Re: Rapiscan AIT System Radiation Survey Reporting

Rapiscan systems <small>by the experts</small>	Secure 1000 Radiation Emission Measurement	FORM R-0646-1 (Single Pose)
---	---	--------------------------------

**R-0646-1 Addendum
(Documentation Errors)**

Product Name	Secure 1000SP (Single Pose)
Serial Number	S51005004
Radiation Emission Measurement	Radiation Survey Dated: 05/25/2010
RSO Initials

1. In Beam Dose Measurement: Survey Table. 1

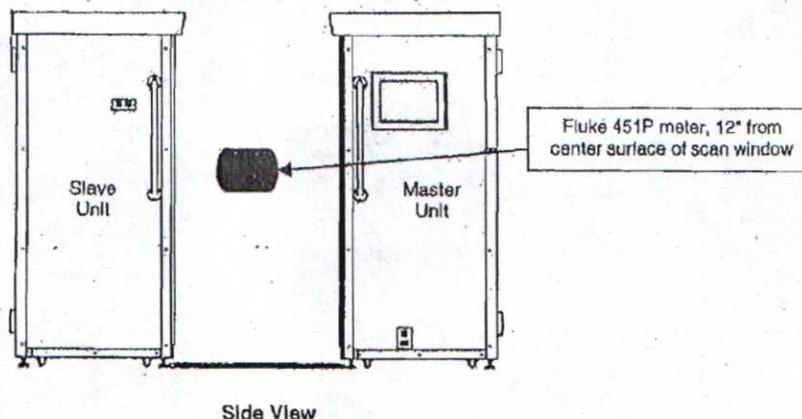
1. No value indicated for background radiation. Typical values range from 7uRem/hr to 13uRem/hr at sea level. Note: Absence of value has no adverse impact on calculations.
2. Technician indicated scan time as 7 seconds. Correct scan time is 3 seconds.
3. TABLE 1: Incorrect presentation of data in Column 3 for Measured Exposure. Indicated values are 32uR and 32uR. Corrected values are 3.2uR and 3.2uR. The values were corrected by technician when calculating Effective Dose.
4. Technician did not record system serial number on survey form. RSO determined system serial number by cross referencing survey form information.

CORRECTIVE ACTION

The corrected data indicates this system was operating within expected parameters. No re-survey is required for this system.
